From: Glaza, Edward <Edward.Glaza@parsons.com>
Sent: Wednesday, August 18, 2021 3:32 PM
To: Mcpherson, Benjamin J (DEC)
Cc: Moreau, George H; Galloway, Rich; Chamberland, Daniel; Clark, Megan; Domanski, Joshua; Schweigel, Tayler; heather.fettig@parsons.com; Lenway, Linda; Martin, Angela L (HEALTH)
Subject: RE: Site 108 Wetland Sampling Optimization
Categories: Review

Figure 7 - Revised

Honeywell TONAWANDA COKE
3800 RIVER RD
TONAWANDA, NEW YORK

Historic Exceedances of Class GA Standards and
Proposed Monitoring Well and Piezometer Locations

Sediment Cores

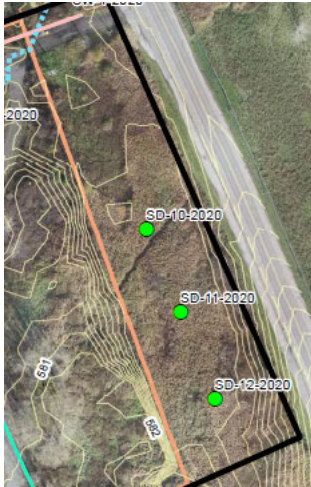
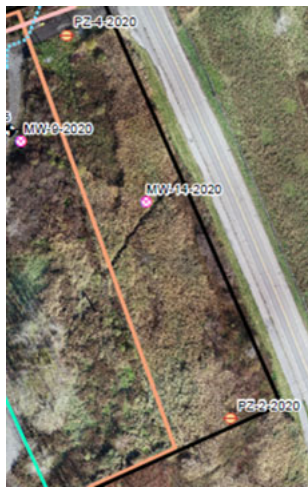
Given the proximity of MW-14 and PZ-2 to the wetland sediment cores, we propose modifying the scope as follows.

- Sampling and analysis of MW-4 and PZ-2 consistent with the sediment core rather than the well/piezometer soil approach. However, consistent with the soil sampling strategy, for the soils deeper than 5 feet, an additional sample will be collected in the 1-foot interval beneath tar, if present. If tar is not present, a sample will be collected from elsewhere in the boring if it exhibits signs of contamination (i.e. staining, elevated PID reading, etc.).
- Eliminating sediment core locations SED 10 and SED 20 (replaced with the sampling above)
- Moving sediment core location SED 11 so it is equal distance between MW-14 and PZ-2, and having the drillers collect the core using a split spoon

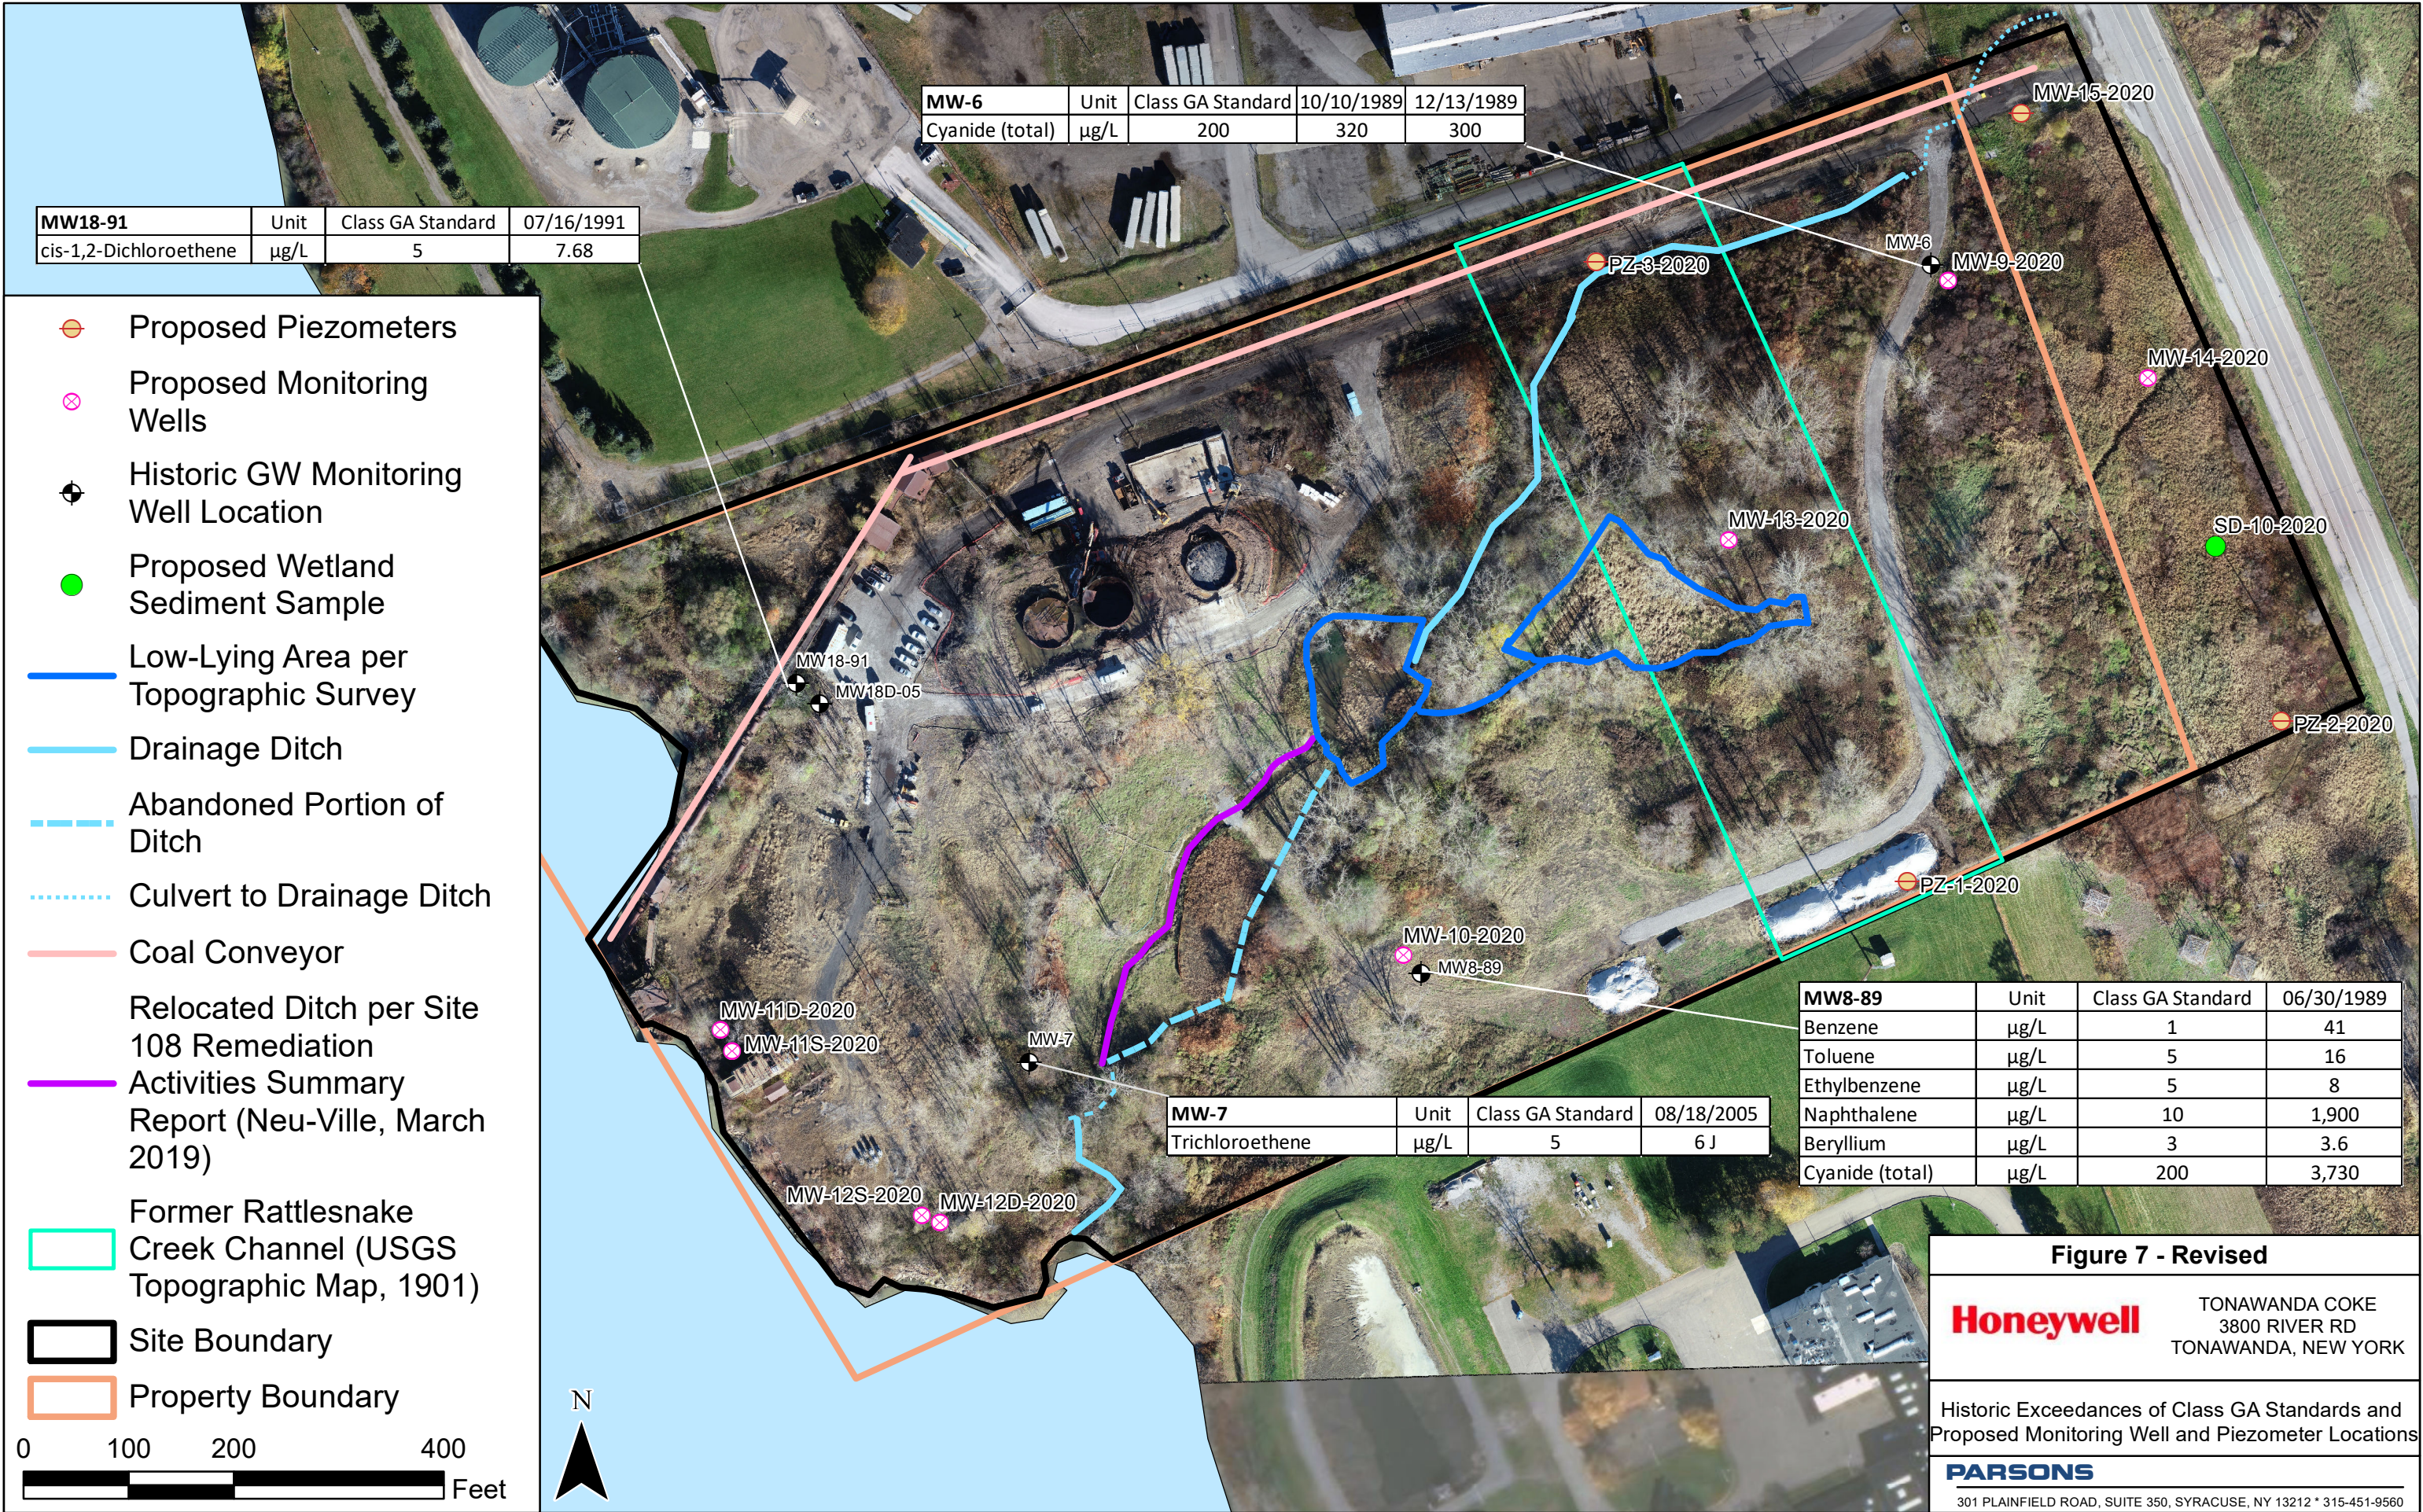
- Sampling and analysis of MW-4 [MW-14-2020] and PZ-2 [PZ-2-2020] consistent with the sediment core rather than the well/piezometer soil approach [samples from 0-6", 6-12", 1-2', 2-3', 3-4', and 4-5' all analyzed for TCL VOCs, SVOCs (including the 34 PAHs specified in NYSDEC 2014), pesticide/PCBs, TAL metals, cyanide, TOC, and PFAS]. However, consistent with the soil sampling strategy, for the soils deeper than 5 feet, an additional sample will be collected in the 1-foot interval beneath tar, if present. If tar is not present, a sample will be collected from elsewhere in the boring if it exhibits signs of contamination (i.e. staining, elevated PID reading, etc.) [sample from >5' will be for SVOCs and TOC only].

- Eliminating sediment core locations SED 10 [SED-10-2020] and SED 20 [SED-12-2020] (replaced with the sampling above)
- Moving sediment core location SED 11 so it is equal distance between MW-14 and PZ-2, and having the drillers collect the core using a split spoon [and renamed SED-10-2020. Will be sampled as described in the first bullet to depth of 5' or native soil, whichever comes first].

Also, considering the limited results I have seen from Site 110 and the BCP site I would request that the >5' soil samples from all the monitoring well/piezometer installations also be analyzed for TCL VOCs.

Figure attached. Note that PZ-4 has been renamed as MW-15 since it was agreed this would be a monitoring well and sampled to verify no impacts from the tunnel under River Road

Will do for these wells/piezometers, however that was not the standard practice for the program overall. For consistency, we will keep the full analytical list. Thanks.

Thanks for the quick response. Only change is the current plan would be to analyze the sample deeper than 5' in the monitoring well/piezometer borings for the full suite (TCL VOCs, SVOCs (including the 34 PAHs specified in NYSDEC
